HANFORD FEDERAL FACILITY AGREEMENT AND CONSENT ORDER
(HFFACO) CHANGE REQUESTS FOR M-45 SINGLE-SHELL TANK (SST) WASTE
RETRIEVAL AND CLOSURE, AND M-46 DOUBLE-SHELL TANK SPACE EVALUATION
AND STATE OF WASHINGTON DEPARTMENT OF ECOLOGY (ECOLOGY)
CONCURRENCE OF ADDITIONAL TANK ACQUISITION

**M-45-04-01 Hanford Federal Facility Agreement and Consent Order
Change Package**

Change Number M-45-04-01	Federal Facility Agreement and Consent Order Change Control Form Do not use blue ink. Type or print using black ink.	Date March 30, 2004																				
Originator Ecology		Phone 736 3038																				
Class of Change <input checked="" type="checkbox"/> I – Signatories <input type="checkbox"/> II – Executive Manager <input type="checkbox"/> III – Project Manager																						
Change Title <u>Hanford Federal Facility Agreement and Consent Order (HFFACO or Agreement)</u> modifications pursuant to Milestone M-45-00C including Appendix D work schedule modifications governing single-shell tank (SST) system waste retrieval and closure, and the establishment of new Agreement Appendix I, "Single-Shell Tank System Waste Retrieval and Closure Process."																						
Description/Ju

Figure I-1.
 Single-Shell Tank Waste Management Area (WMA)
 Waste Retrieval and Closure Process

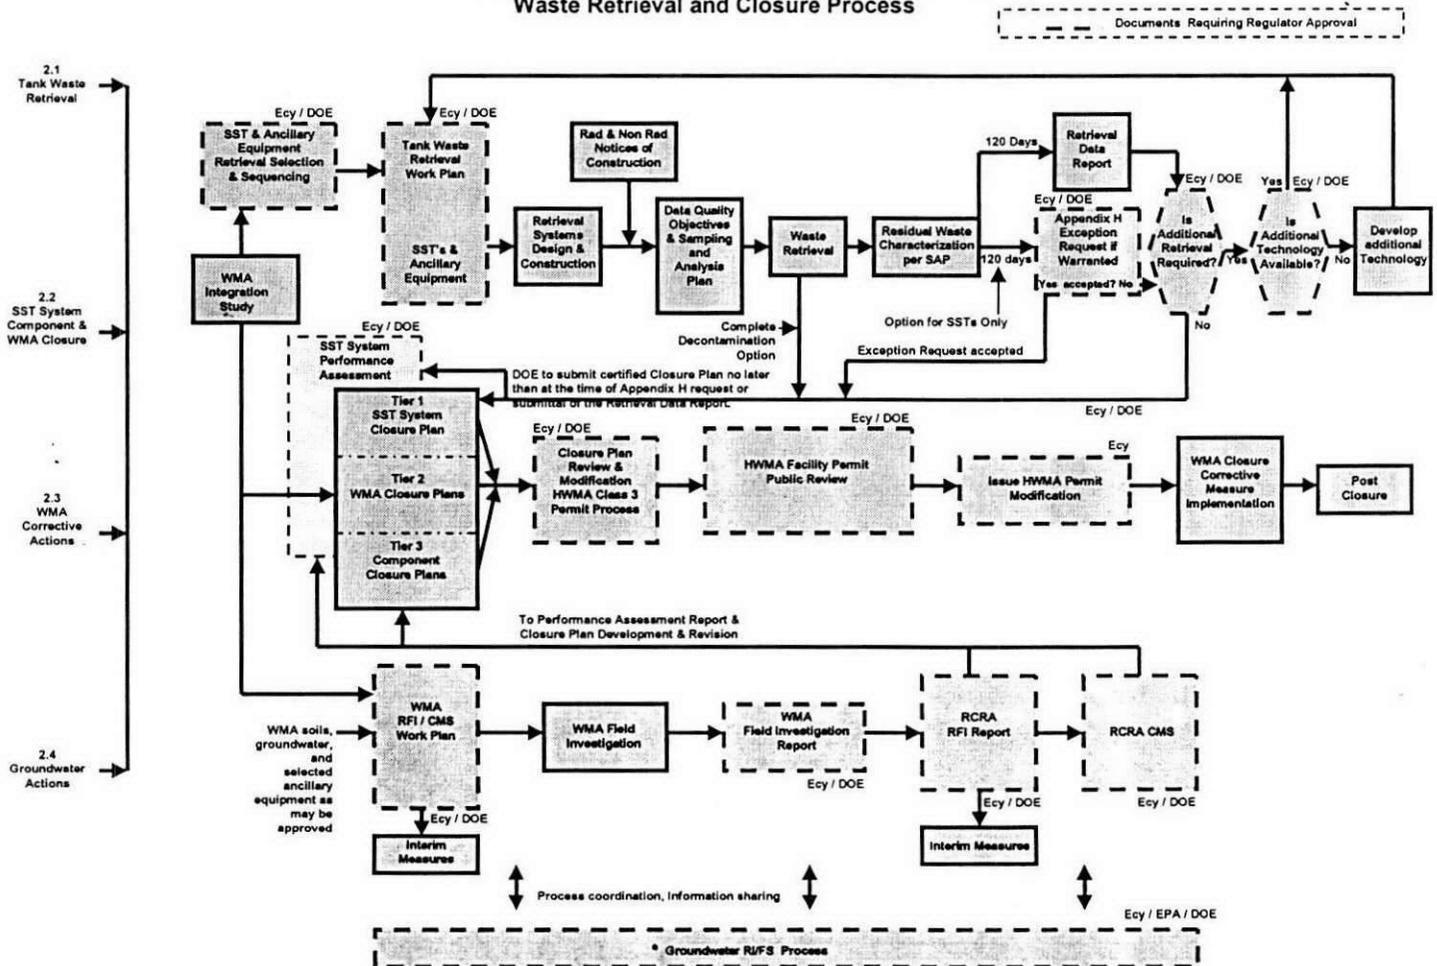
Figure I-1 depicts the process DOE is required to follow during SST WMA waste retrieval and closure. It identifies four main areas of emphasis: Tank waste retrieval; SST system, WMA and component closure, including WMA corrective action; and groundwater actions. These areas are discussed in greater detail in the following sections of this appendix. Each box within Figure I-1 identifies an action needed to achieve closure of the SST system. Actions or deliverables requiring approval by Ecology are identified.

As shown in Figure I-1, SST waste retrieval will occur prior to or in parallel with approval of modifications to the SST system closure plan. At the latest, DOE shall submit a certified component(s) closure activity plan with its retrieval data package or its Appendix H exception request. As noted in Sections 2.3 and 2.4, *Resource Conservation and Recovery Act of 1976 (RCRA)* corrective action authority may be used to develop proposed final actions for some SST system components with approval to occur by Ecology through incorporation of the component closure plans into the Site-Wide Permit.

Figure H-1. Process for Assessing Percentage of Waste Retrieved from Waste Retrieval Operations

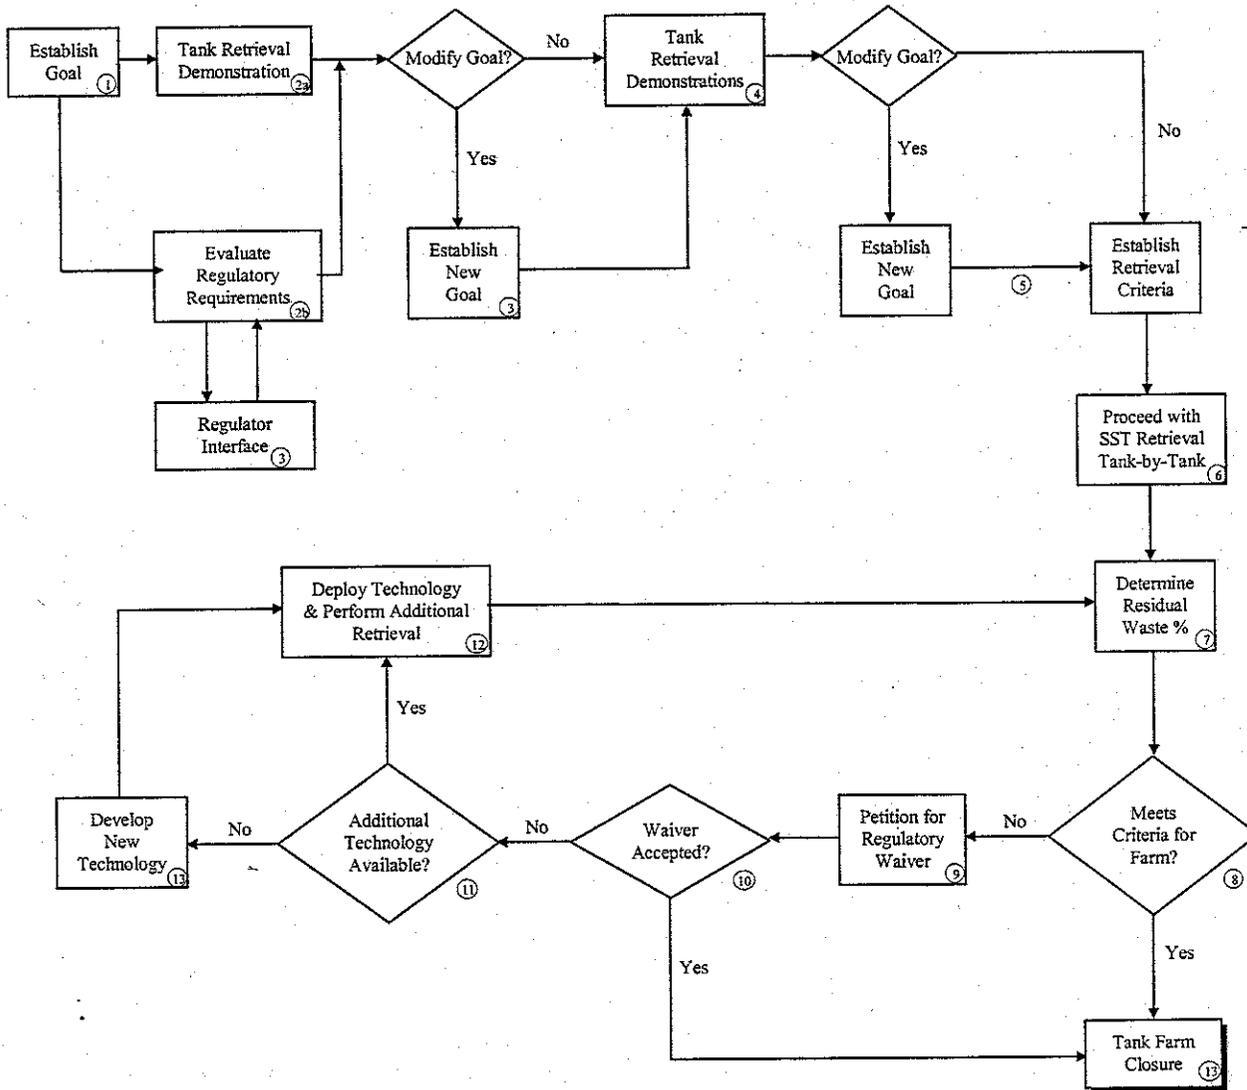
Modifications to Appendix H incorporated into the HFFACO by approval of this M-45-04-01 Change Request are shown here as either **shaded** additions or **strikethrough** deletions.

The format for this procedure is to progress through a series of steps as depicted in the generic logic diagram displayed as Figure 1. Each step is briefly outlined and includes elements that constitute completion of the step.
